Zoning Staff Report

Case Number: ZC-26-035

Site Location: 2606 Hemphill Street

Site Plan Comments

LOT 6R, PART OF 6 & PART OF 7, BLOCK 2
 BLANCHARD ADDITION
 0.831 ACRES

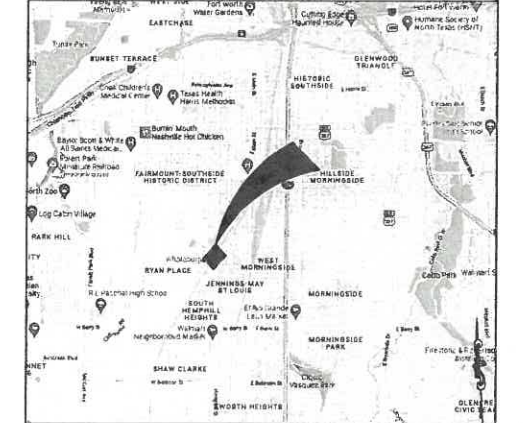
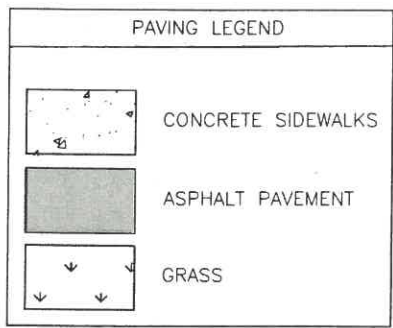
1. The site plan and all its details need to be clearly visible at any scale.
2. Legal description is noted, but is not required to be the full metes & bounds description. Leaving the legal description as only the Lot, Block, and Subdivision will make room for other notes.
3. Graphic scale is included, but is not legible.

4. Rotate the north arrow to the correct orientation.
5. The engineer created this site plan in 2022, so the person who modified his drawing needs to be clearly identified as the site designer with their name, address, and email noted.

6. Remove the "Preliminary for review only note" as site plans are finalized upon submission to Zoning Commission.
7. A vicinity map is included, but is not legible.

8. The dimensions of the building to the property lines need to be added.
9. The proposed use(s) of the building and requested zoning district is not listed.

11. The shed located west of the building must be moved out of the supplemental setback.
12. The building entrances and exits for pedestrians on the north side are shown. However, if the building is converted to a warehouse or contractor's shop, these uses have overhead doors that would need to be added. Where a semi-truck would load/unload for a warehouse use without blocking the fire lane/drive aisle is not readily apparent.

13. The number of parking spaces available is not noted.
14. The site plan does not show how a semi-truck would tun around on this site.
15. The parking calculations for a warehouse/commercial use/contractor's shop are not included. The site may be over-parked and require additional trees.

16. The bike rack location is not clear.
17. What is the purpose of the gravel and sidewalk west of the existing parking lot?
18. The location of landscaping and the required supplemental setback lines adjacent to residential uses are not shown.

19. The site plan does not show how the parking lot would meet the 40% canopy coverage.
20. The location of a dumpster and its enclosure are not shown.
21. Show and label the ground mounted air conditioners. If no air conditioners will be ground mounted, add a note stating where they will be located.

22. The fencing must be entirely converted to fencing that meets the solid screening requirements, instead of having a mix of fencing types. The fence height also needs to be noted.

23. The land uses and zoning on Lot 9 to the south is not noted.
24. The sign location is included, but is not legible. The sign style is not listed. Note if the sign will be illuminated or unilluminated.

25. Label the land use and zoning classifications of all immediately adjacent properties abutting the site.
26. Comments may be modified or added.
